BULLETIN No. 164

TEHACHAPI CROSSING
DESIGN STUDIES

Book V

AUGUST 1965

SCHEMATIC DIAGRAM
TWO-LIFT
PUMPING SYSTEM FOR
TEHACHAPI CROSSING

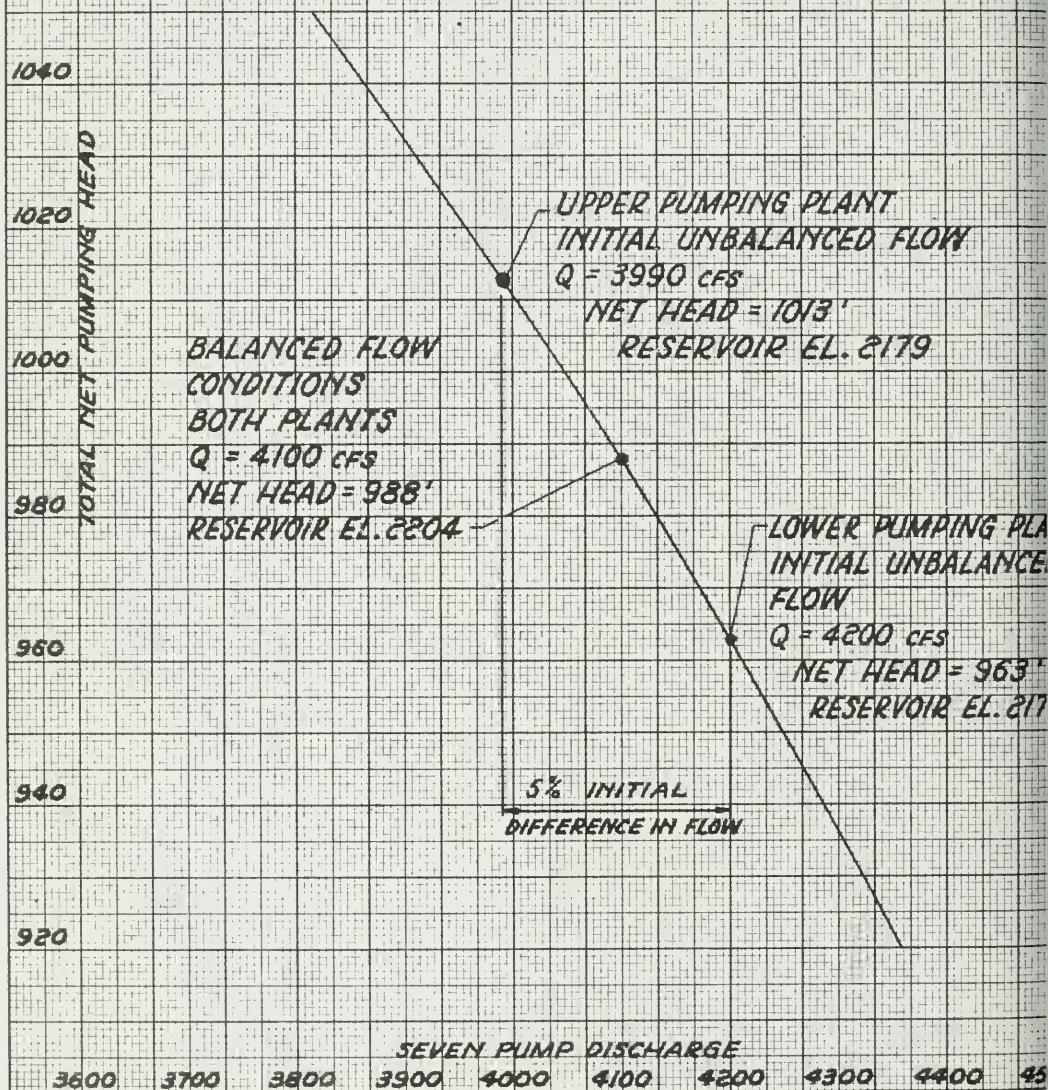
The District recommends that a two-lift system on the ridge alinement be adopted for construction on the Tehachapi Crossing using two-stage, double-flow pumps and an off-line dam and reservoir at the second lift, similar to that shown in the Department of Water Resources' Report on Alternative Locations of Tehachapi Pump Lift System dated April 1965, Plate 6, titled System Ridge Two Equal Lift Plan and Profile, with the exception that underground delivery lines be considered in lieu of surface discharge lines and except that the District favors horizontal setting of the two-stage, double-flow pumps.

At the first pumping plant the centerline of the shaft on the pump would be located at least 70 feet below the minimum operating water surface elevation in the forebay, or approximately at elevation 1159. This should result in a suction specific speed of approximately 6500 at the most adverse operating conditions. At the second plant the centerline of the shaft would be placed approximately 70 feet below the minimum water surface in the reservoir or at elevation 2094. The high water level in the reservoir should be at elevation 2229 and the low water elevation should be 2164. With this difference of elevation, there will be ample opportunity for a change in water level in the reservoir and a resulting change in the net head on the pumps to adjust the flow of the pumping units in the first plant at the bottom of the lift with those at the second plant at the reservoir.

INSTALLATION OF A VIANDEN PUMP

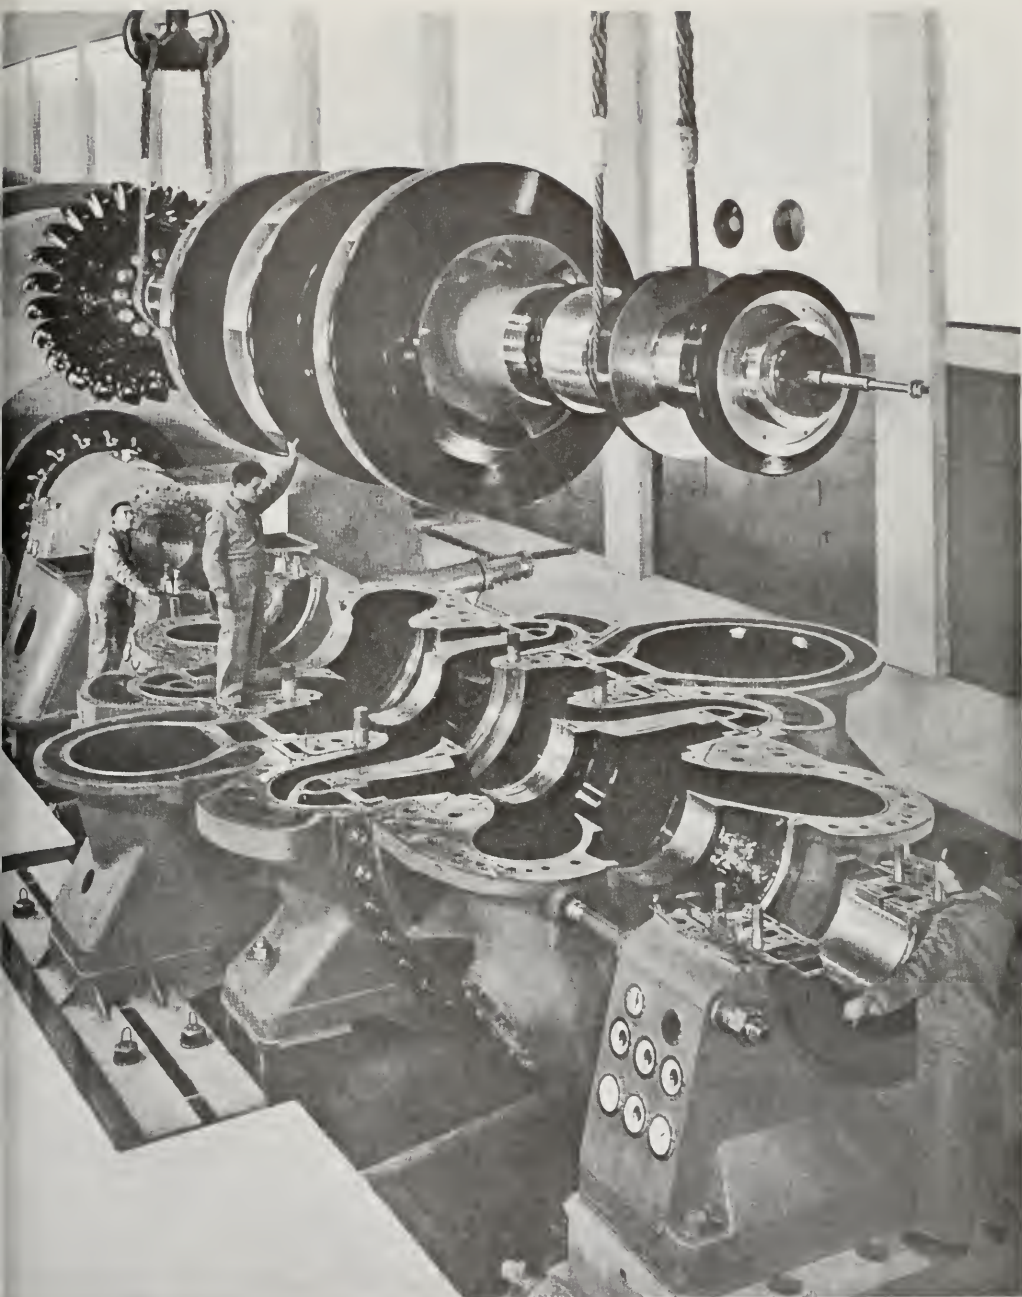
"Of the twenty-three pumping plants included in this report, six contain vertical units while seventeen have pumps with a horizontal shaft arrangement. The latter includes Vianden where nine horizontal units with a pump rating of 93,400 HP each are installed in an underground station."

"Referring to this special type of pump, I must mention the horizontal splitting of the housings, where the sealing of the two parts seems to be resolved. Wherever these split housings are adopted - in Bringhausen, Provvidenza, Limberg, and now in Vianden - the plant operating staff is convinced of the many important advantages of this solution."
